ULNRC-03320
TAC NO. M92975

CALLAWAY PLANT
DOCKET NUMBER 50-483
REVISION TO TECHNICAL SPECIFICATION
3/4.6 CONTAINMENT ISOLATION VALVES
Reference: ULNRC-3227 dated June 26, 1995

SAFETY EVALUATION

Penetration 74

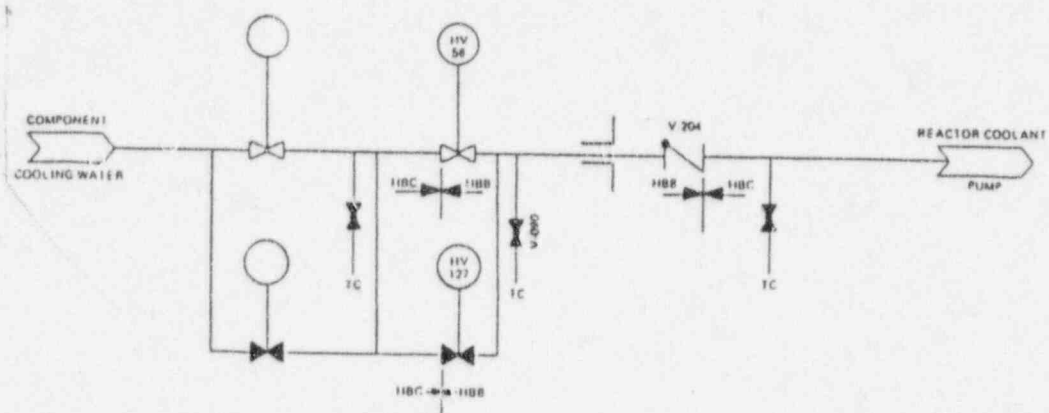
The proposed change to use check valves as isolation devices as allowed in TS LCO 3.6.3 Action Statement c. is not applicable to Penetration 74 (CCW to reactor coolant pumps) because the outside containment supply line consists of two motor-operated valves in parallel, one automatic isolation valve and one remote manual isolation valve. This design ensures that there is a supply of water to the reactor coolant pumps, but results in a situation whereby two valves must be closed to satisfy the TS action statement. Allowing 12 hours to restore the inoperable valves is acceptable because the system is closed (isolated from the RCS with flow through the penetration) and the penetration can still be isolated by the in-containment isolation device.

Penetrations 74 and 75 were not considered because plant operation could not continue with these penetrations isolated.

Explain how the MOVs for penetrations 74, 75, and 76 are configured (i.e., able to close against design DP).

The primary valves (automatic isolation valves) are setup to close against maximum differential pressure (DP).

The bypass valves have no active safety function and are only opened under administrative control as is currently required by TS Table 3.6-1. The administrative controls for the bypass valves will be retained with Table 3.6-1 when relocated to the Callaway FSAR and will consist of written procedures, training for operators on those procedures, and the availability of an operator, if needed, to manually close the valve(s). These controls conform to the requirements of Generic Letter 91-18.

The control room operator will be responsible for remotely closing those bypass valves capable of operating against maximum DP. An operator, stationed at the valve, will be responsible for closing the bypass valve(s) not capable of operating against maximum DP (for those bypass valves located outside containment).

Penetration 76

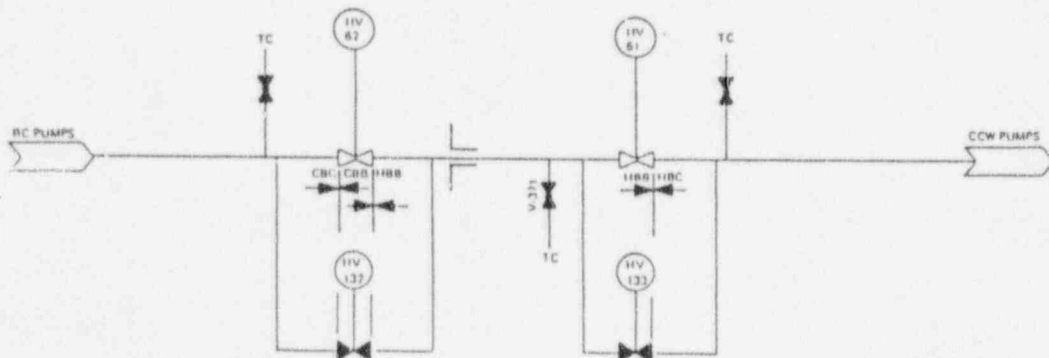
How are CDF (or CDP) and the LERF (large early release frequency) affected if the penetration is isolated and is maintained isolated, thereby terminating CCW flow to the RCPs? Would any of the small break LOCA sequences be affected?

Are the CDF or LERF affected at all by increasing the allowed outage time from 4 to 12 hours? If so, by how much?

In order to respond to this question, relevant loss of RCP seal cooling accident sequences were requantified, with CCW flow to the RCP thermal barrier cooling coils failed. (Penetration 76 was assumed to be isolated for an indefinite period of time.) This requantification resulted in a revised total CDF of approximately $2.3\text{E}-4$ per year. This represents an increase of approximately 300% over the CDF of $5.846\text{E}-5$ per year reported in the Callaway IPE submittal.

A probabilistic evaluation was performed to determine if increasing the AOT, from 4 to 12 hours, resulted in a significant increase in the Callaway containment isolation unavailability (failure probability). This was accomplished by developing a simplified fault tree model of failure to isolate penetration P-76, given that one of the containment isolation valves, EGHV61 or 62, was deemed inoperable and was being worked. The simplified fault tree is provided as Attachment 4.

In order to determine a baseline failure to isolate probability, i.e., a probability corresponding to the 4 hour AOT, the fault tree was quantified with the EGHV61-OPEN and EGHV62-OPEN scalar events set to 1.0. The resulting unavailability/failure probability was $3.14\text{E-}8$. The fault tree solution cutsets from this quantification are provided as Attachment 5.

The fault tree solution cutset equation was then requantified with the above scalar events set to 3.0 to represent the 12 hour AOT. The resulting failure probability was $4.89\text{E-}8$. The increase, then, associated with the 12 hour AOT is $1.75\text{E-}8$ (i.e., $4.89\text{E-}8$ minus $3.14\text{E-}8$).

The percentage increase in overall containment isolation failure probability, due to the increase in AOT from 4 to 12 hours, is $3.9\text{E-}2$ percent ($1.75\text{E-}8$ divided by $4.53\text{E-}5$, times 100%). Consequently, the increase in containment isolation failure probability due to the increased AOT is deemed insignificant.
